P10
V1.6.0
2025-04-16

Release Notes

1 V1.6.0

1.3.2 LCD Screensaver

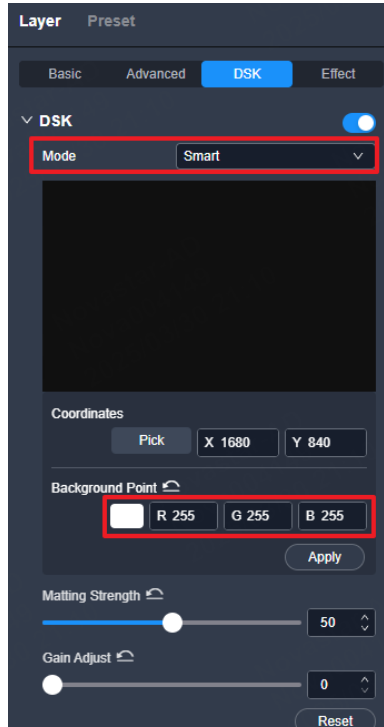
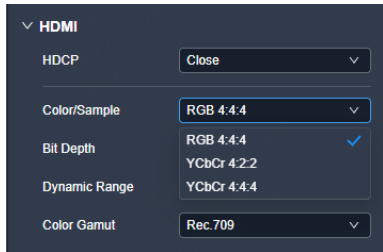
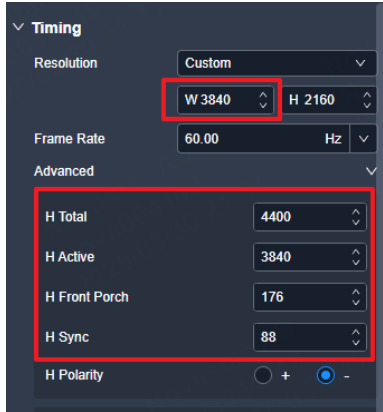
Prolonged display of a static image on the LCD screen may cause screen burn-in. Using a screensaver can effectively protect the screen.

- When the LCD remains inactive for more than one minute, a screensaver will appear.
- The screensaver will be displayed over the current screen, without redirecting to the home screen.
- To exit the screensaver, press any button on the front panel.
- Icons within the screensaver will move along a set path at a consistent frequency.
